Technical Service Bulletin

Topic	Mono Camera Requires Replacement Bentayga 17-19MY
Market area	Bentley: worldwide (2WBE),China 796 VW Import Comp. Ltd (Vico), Beijing (6796)
Brand	Bentley
Transaction No.	2078364/1
Level	EH
Status	Released for publishing
Release date	Nov 14, 2025

The front camera for driver assistance programs (mono camera) requires replacement.

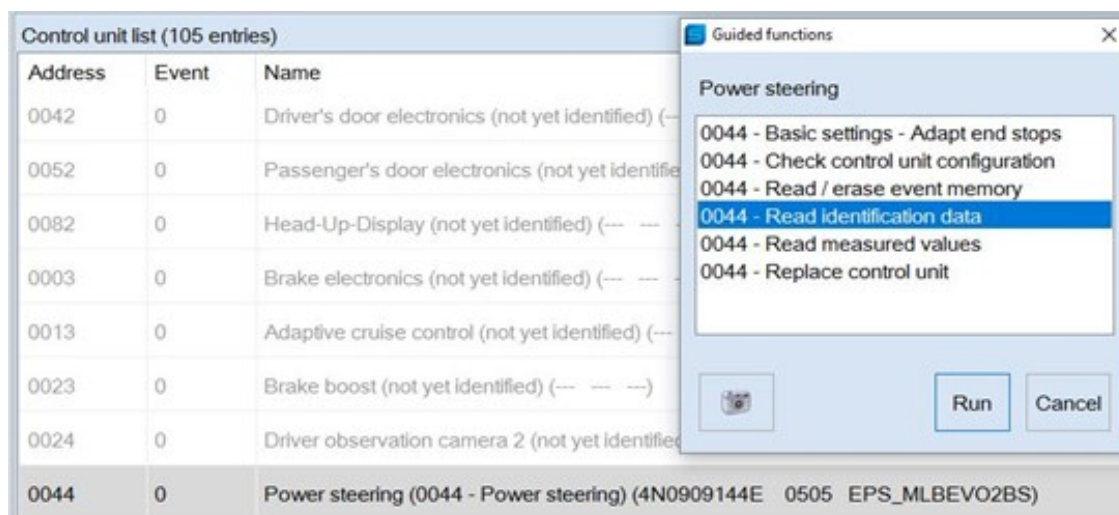
If the front camera for driver assistance programs (mono camera) requires replacement, the new part that is fitted must be the D level part (see the parts information section).

Refer to the measure section for further instructions.
